RE: DRAFT - Self-Implementing PCB Remediation  
USEPA ID Number NYD 003 907 045  
Former Empire Electric Company  
5200 1<sup>st</sup> Avenue  
Brooklyn, NY 11232

1. EA is notifying EPA on behalf of NYSDEC that previously inaccessible material has been uncovered and sampled in the performance of this IRM.
2. EA is informing EPA of a change in site conditions from information provided in the notification ("Application")
3. EA proposes a modification to EPA's September 23, 2014 approval, that the IRM being performed be considered the final cleanup of PCB remediation waste from the site.

## PCB TEST PIT LOCATIONS

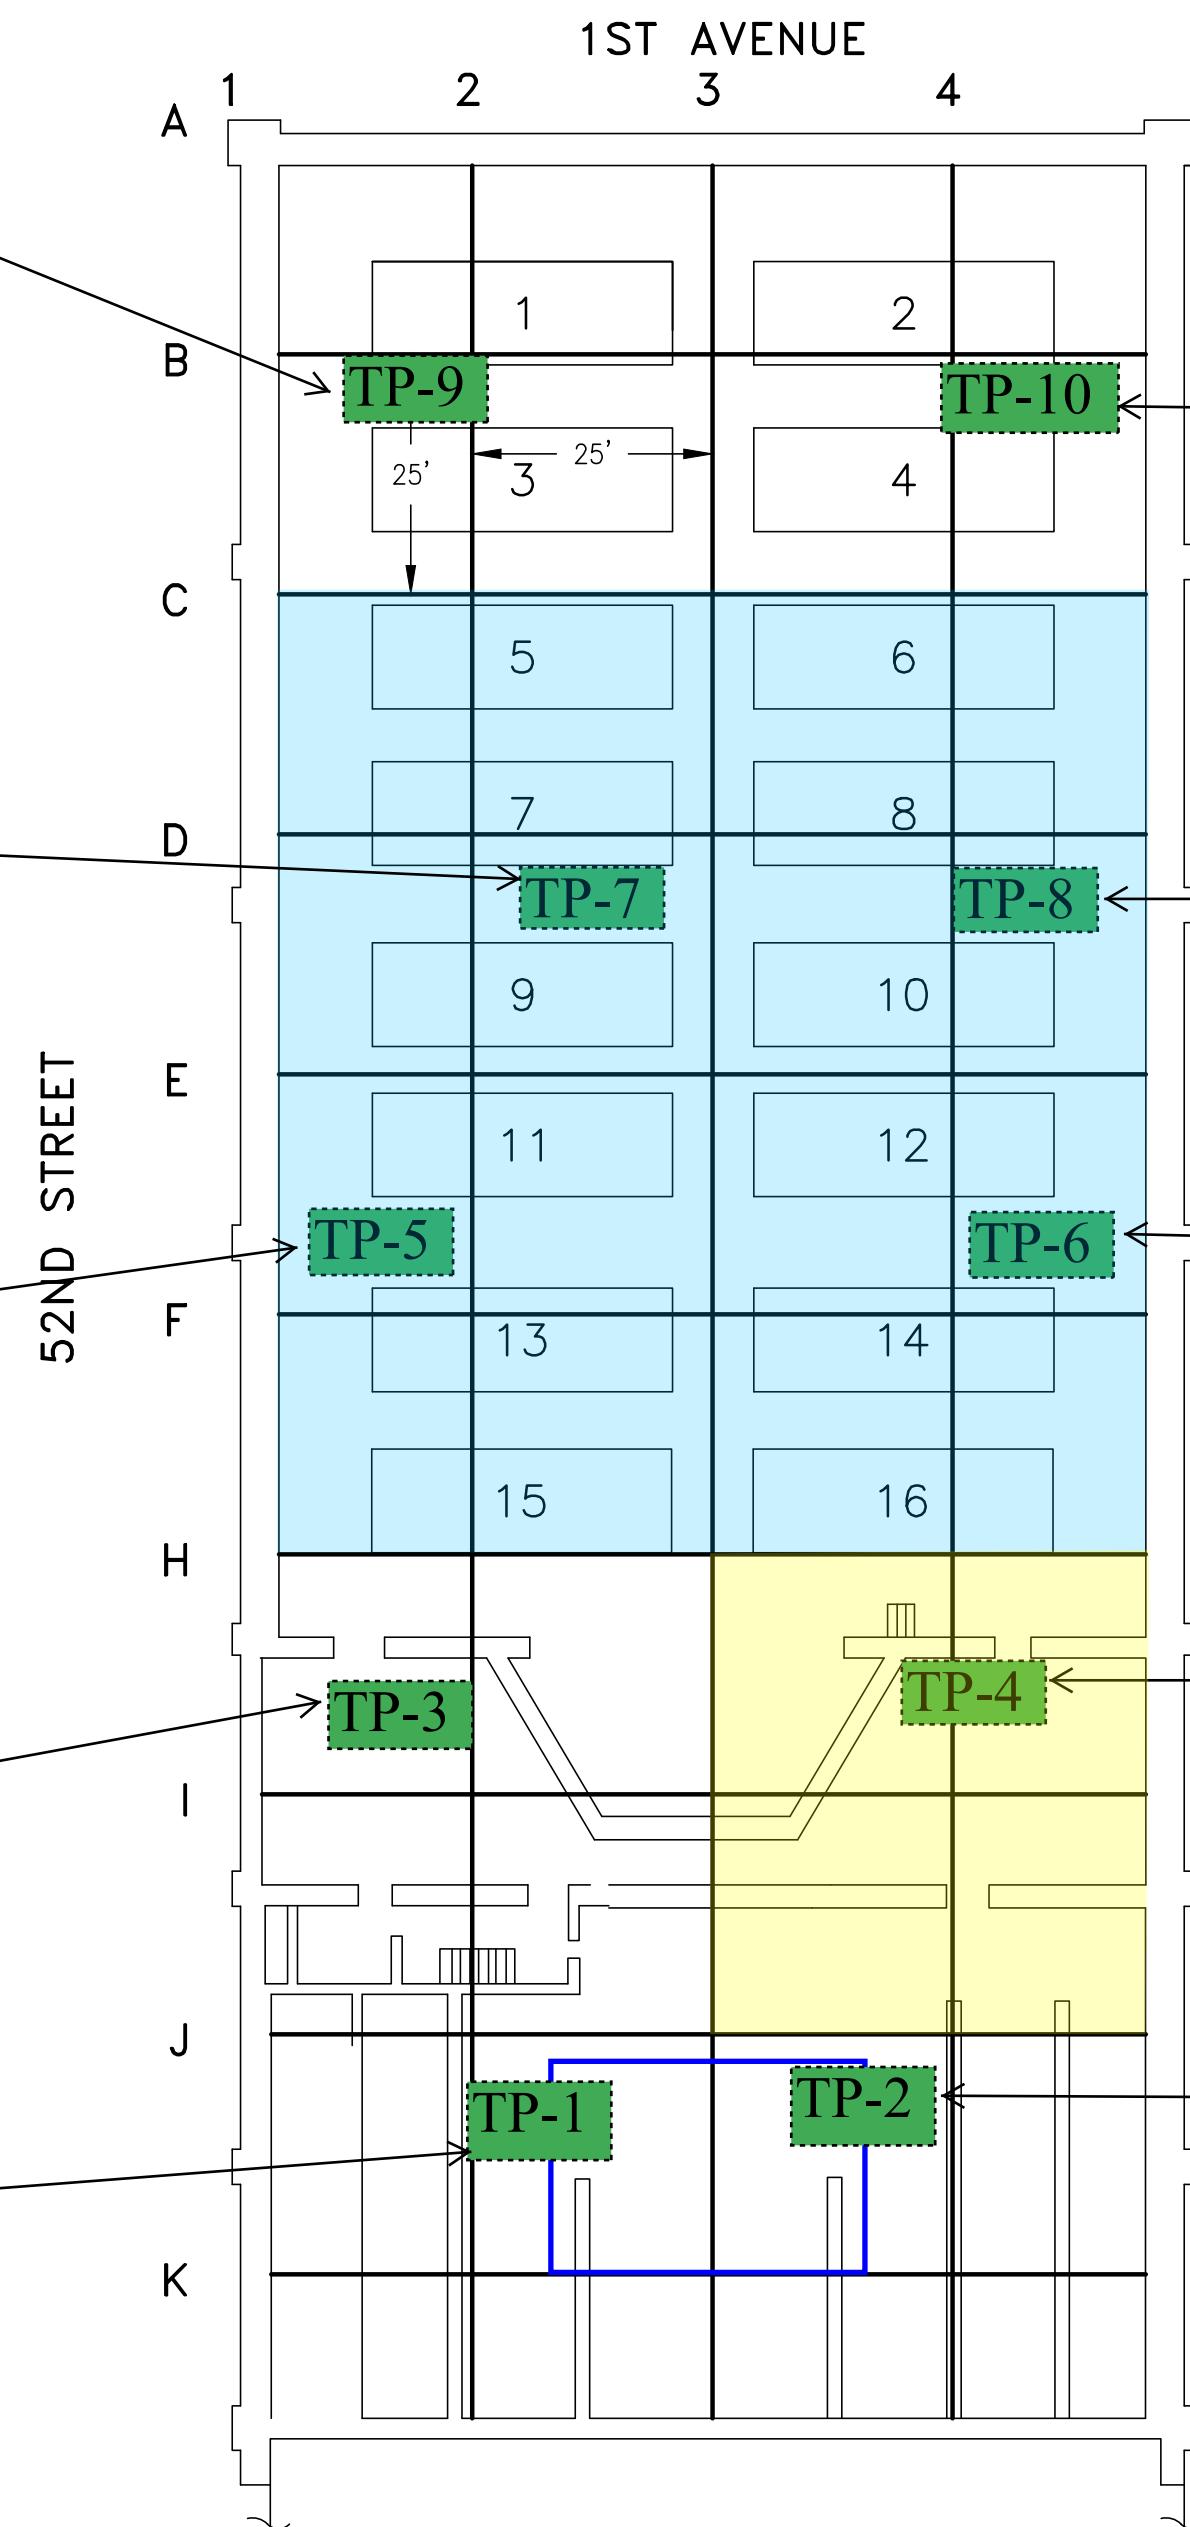
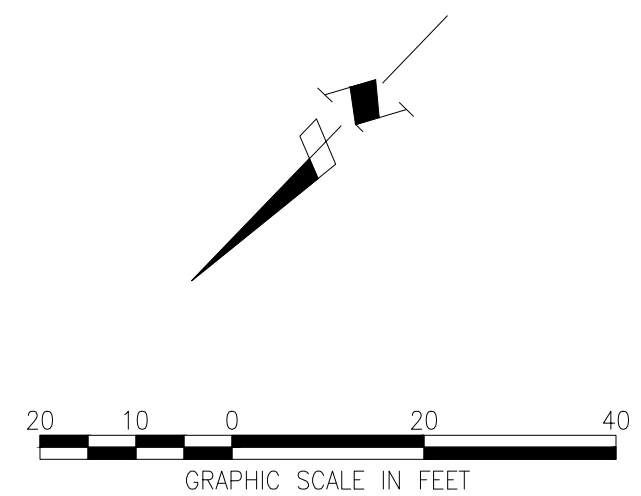
The Demolition Drawings submitted to EPA were based on limited information regarding the structure's foundation. The structure included a network of column (pier) foundations that supported former steam driven electric generators (dynamometers). The piers combined with a structurally compromised floor slab presented a safety and logistical challenge to characterizing material below the cellar floor. This condition made it difficult to thoroughly assess the structure's foundation elements prior to building demolition. The PCB data presented in the 2009 notification was limited to building material above and including the surface of the cellar slab. To cleanup PCBs from the site NYSDEC awarded Contract No. D007630 to PAL Environmental Services, Inc. (PAL) of Long Island City, New York, and issued a Notice-to-Proceed on July 2, 2014. During the course of building demolition activities previously uncharacterized building material (inaccessible before demolition activities), has been sampled. PAL used a small excavator to remove portions of the cellar slab revealing approximately 6 ft. of brick rubble. For the purpose of creating waste profiles for the brick rubble, ten test pits were excavated (see Figure 1), and two 5-point composite samples were collected from each test pit at depth intervals of 0–3 ft. and 3–6 ft. Of the 20 composite samples collected all the PCB concentrations were less than 50 milligrams per kilogram (mg/kg). After discussing sample results with EPA it was determined that the composite sampling is not appropriate for characterizing PCB remediation waste (Subpart N) and therefore the rubble material will be managed as TSCA waste and be disposed of at TSCA permitted landfill.

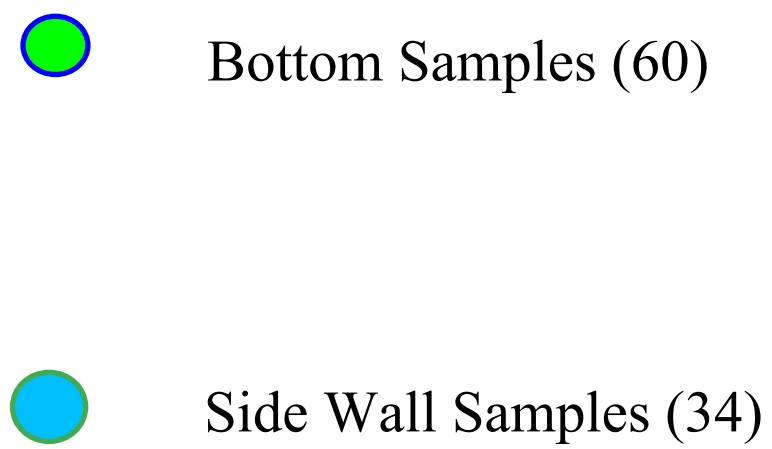
cleanup objective of 1 mg/kg. The proposed sampling to verify completion of the PCB cleanup will be performed by sampling on a 20 ft. grid as shown on Figure 2. Samples grids that exceed the cleanup objective of 1 mg/kg will have the entire grid area scarified using either hand held jack hammers or a hydraulic hammer mounted on an excavator then be resampled. In the event that scarification is not effective at achieving the cleanup objective the impacted grid area will be encapsulated with a double coating of epoxy (as identified in the Application).
